**Performance Characteristics Subcommittee
Unapproved Meeting Minutes – Boston, MA – November2, 2011**

10.4 Performance Characteristics Subcommittee – Stephen Antosz, Chairman; Ed teNyenhuis, Vice-Chair; Craig Stiegemeier, Secretary

10.4.2 PCS WG on “Test Code C57.12.90” – Mark Perkins, Chairman; Craig Stiegemeier, Secretary

Figure 9. Connections for Ratio Test on a Transformer with Inaccessible Neutral

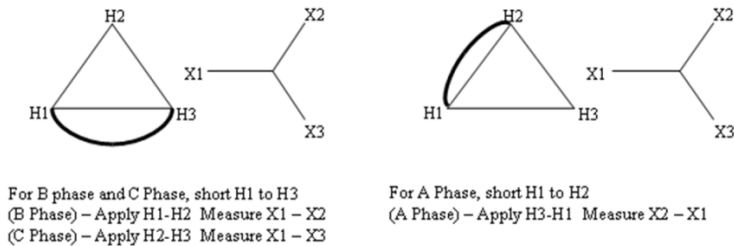
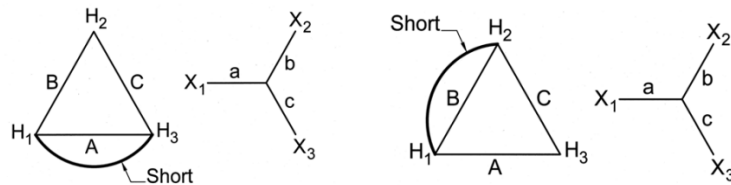
- Jennifer Yu offered the following comment: “The portion directly above Figure 9 could be explained in more detailed text, for example, apply voltage between H1-H2 terminals, and measure voltage between X1-X2 terminals. This would make it much clearer to read and understand, instead of some symbols.” A discussion of this comment was held. Bertrand Poulin noted a recent test floor experience. Baitun Yang of PA Transformer questioned the practice of creating a virtual neutral. Kipp Yule noted that there could be some confusion when using the Phase A, B and C designation, which is similar to the following comment from Barry Ward. The Working Group agreed that the comments surrounding the figure were adequate to explain the concept.

- Barry Ward offered the following comment: “Paragraph 7.1.4: I think the diagram should show which phases are A, B and C. I've used the following diagram in a recent document which you are welcome to have if you want.” The Chair suggested

Change Recommended by Barry Ward

that this would not impact the survey and may make the figure clearer to understand. Thompson made motion, Joe Melanson seconded the motion, and 39 members approved, no one disagreed with making the change to this figure.
